**Project** 28 Lockwood Avenue, Belrose

**Report** BCA Assessment Report

**Reference** C21844-BCA Report-r2

**Date** 27 September 2022

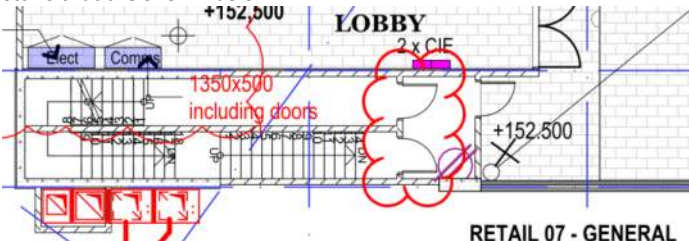
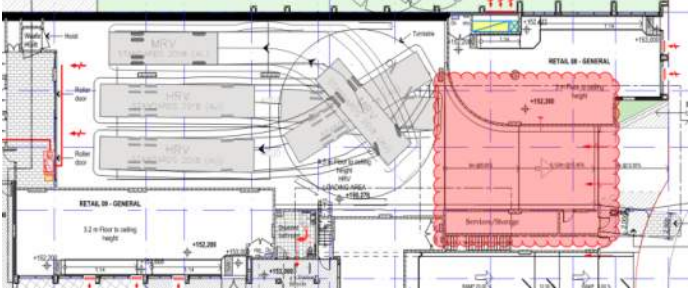
<p>D1.6 Dimensions of exits and paths of travel to exits</p>	<p>The stair widths may need to be widened to provide 1m clear widths.</p> <p>Please note a constructed width of approximately 1,100mm is required to install a compliant handrail to one (1) side of a stairway (as required for a fire-isolated stairway), and a constructed width of approximately 1,200mm is required to install compliant handrails to both sides of a stairway (as required for a non-fire-isolated stairway).</p> <p>Termination of handrails must be considered in the design (see part 5.5 of this report).</p> <p><b>Basement 04 fire-isolated stairway –</b>                      Three of the four fire-isolated stairway have will have issues with travel width when correct handrail terminations are provided. These</p>	<p>DNC</p>

Clause	Comments	Assessment
	<p>are the southwest, north central and southeast fire-isolated stairway. These stairways are highlighted in red below:</p>  <p>There is insufficient room to provide a 1m clear width to the fire hydrant when a compliant handrail is installed. A compliant handrail must continue one tread beyond the bottom riser and then 300 mm horizontal. This requires a space of <math>1000 + 250 + 300 = 1550</math> mm. As shown above only 1390 mm is provided to these three fire-isolated stairways. This will only provide a travel width of 880 mm which is less than the 1m minimum required.</p> <p><b>Residential fire-isolated stairway –</b>                      The southwest and northwest residential fire-isolated stairways have insufficient room to provide a 1m clear width when a compliant handrail is installed. A compliant handrail must continue one tread beyond the bottom riser and then 300 mm horizontal. This requires a space of <math>1000 + 250 + 300 = 1550</math> mm.                      The southwest residential fire-isolated stairway is only provided with 1140 mm (shown below). This will only allow a clear width of 590 mm.</p>

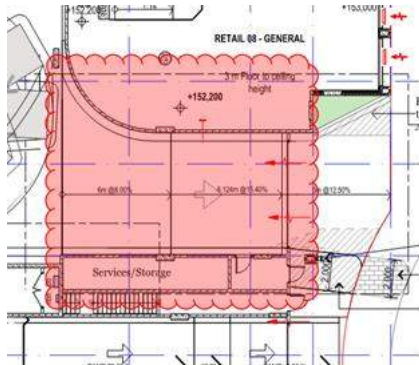
Clause	Comments	Assessment
	<p>The northwest residential fire-isolated stairway is only provided with 1382 mm (shown below). This will only allow a clear width of 832 mm.</p>  <p><b>SOLUTION</b> All stairway designs should be revisited and the location of a compliant handrail should be detailed. Please review figures in section 5.5 of this report and review each handrail design so adequate space in the stairs is provided.</p>	
<p>D1.7 Travel via fire-isolated exits</p>	<p>A doorway from a room must not open directly into a stairway, passageway or ramp that is required to be fire-isolated unless it is from—</p> <ol style="list-style-type: none"> <li>4. a public corridor, public lobby or the like; or</li> <li>5. a sole-occupancy unit occupying all of a storey; or</li> <li>6. a sanitary compartment, airlock or the like.</li> </ol> <p>Each fire-isolated stairway or fire-isolated ramp must provide independent egress from each storey served and discharge directly, or by way of its own fire-isolated passageway—</p> <ol style="list-style-type: none"> <li>4. to a road or open space; or</li> <li>5. to a point—             <ol style="list-style-type: none"> <li>(A) in a storey or space, within the confines of the building, that is used only for pedestrian movement, car parking or the like and is open for at least 2/3 of its perimeter; and</li> <li>(B) from which an unimpeded path of travel, not further than 20 m, is available to a road or open space; or</li> </ol> </li> <li>6. into a covered area that—             <ol style="list-style-type: none"> <li>(A) adjoins a road or open space; and</li> <li>(B) is open for at least 1/3 of its perimeter; and</li> <li>(C) has an unobstructed clear height throughout, including the perimeter openings, of not less than 3 m; and</li> <li>(D) provides an unimpeded path of travel from the point of discharge to the road or open space of not more than 6 m.</li> </ol> </li> </ol> <p><b>Discharging internally</b> There are multiple fire-isolated exits that do not provide egress directly to open space or alternative covered areas as allowed by this clause. These fire-isolated exits are</p> <ol style="list-style-type: none"> <li>7. the southwest residential fire-isolated stairway,</li> <li>8. the southwest basement fire-isolated stairway,</li> <li>9. the central north residential fire-isolated stairway,</li> <li>10. the central north basement fire-isolated stairway,</li> </ol>	<p>DNC/PS</p>

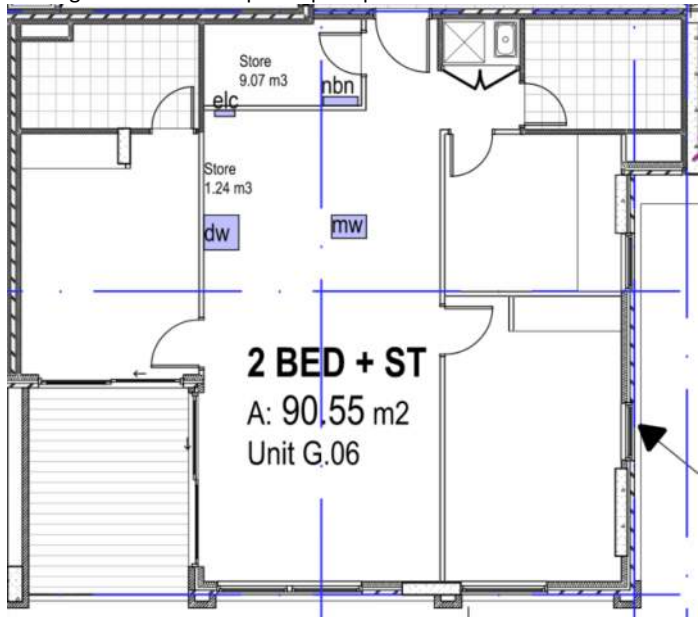
Clause	Comments	Assessment
	<b>SOLUTION</b> Adjust the doorway location to avoid being located on a ramp.	
D2.11	Fire-isolated passageways The fire-isolated passageways must have the required FRL of the stairways that discharge into it.	CRA
D2.12	Roof as open space The minimum FRL of a roof used as open space is 120/120/120. This applies to all basement carparking roof that is used as a path of egress. The roof must not have any roof lights or other openings within 3 m of the path of travel of persons using the exit to reach a road or open space.	CRA
D2.13	Goings and risers Stair geometry and treads slip resistance must comply with this Clause.	CRA
D2.14	Landings The geometry and slip-resistance of landings must comply with this clause.	CRA
D2.15	Thresholds The threshold of a doorway must not incorporate a step or ramp at any point closer to the doorway than the width of the door leaf unless: (c) in a building required to be accessible by Part D3, the doorway— (i) opens to a road or open space; and (ii) is provided with a threshold ramp or step ramp in accordance with AS 1428.1; or NSW (e) in other cases— (i) the doorway opens to a road or open space, external stair landing or external balcony; and (ii) the door sill is not more than 190 mm above the finished surface of the ground, balcony, or the like, to which the doorway opens.  <b>Ramp serving loading dock exit:</b> The ramp serving the loading dock exit is within the width of the door leaf of the doorway. The cross fall has a gradient of 15.4%. This is shown below:  <b>SOLUTION</b> Adjust the doorway location to provide a compliant threshold.	DNC
